REMARKS

Claims 1 through 16, 18, 20 through 32 and 34 remain in this application. Claims 17, 19, 33 and 35 have been canceled. Claims 1, 3, 18, 22, 24 and 34 have been amended.

Fig. 2

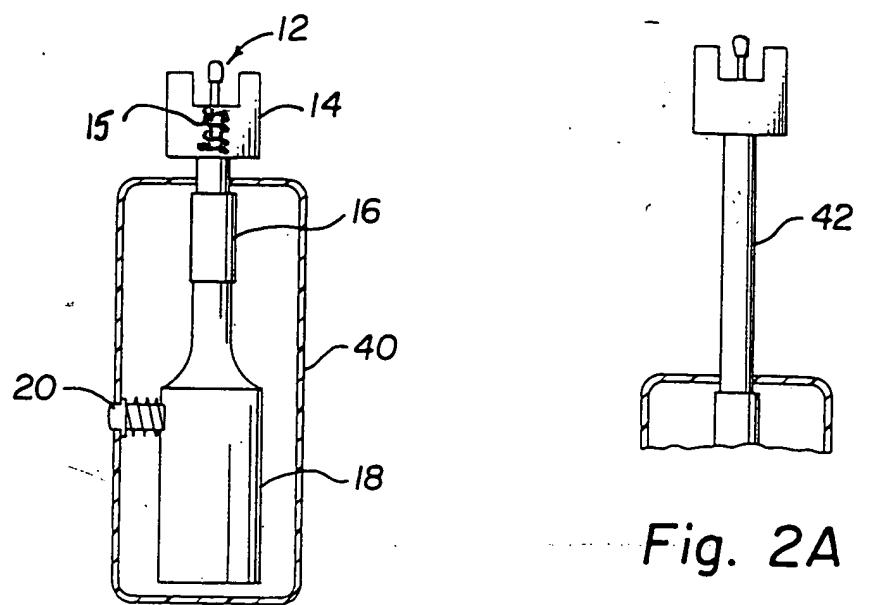
The drawings were objected to under 37 C.F.R. 1.83(a) because the resilient member described in the claims was not shown. A proposed drawing change to Figure 2 is attached hereto with the additions shown in red. The resilient member has been added to Figure 2 as part number 15. In addition, paragraph 29 has been amended to include the reference to part number 15 in the description. The addition of resilient member 15 to the drawing adds no new matter since the resilient member was already clearly described in the specification.
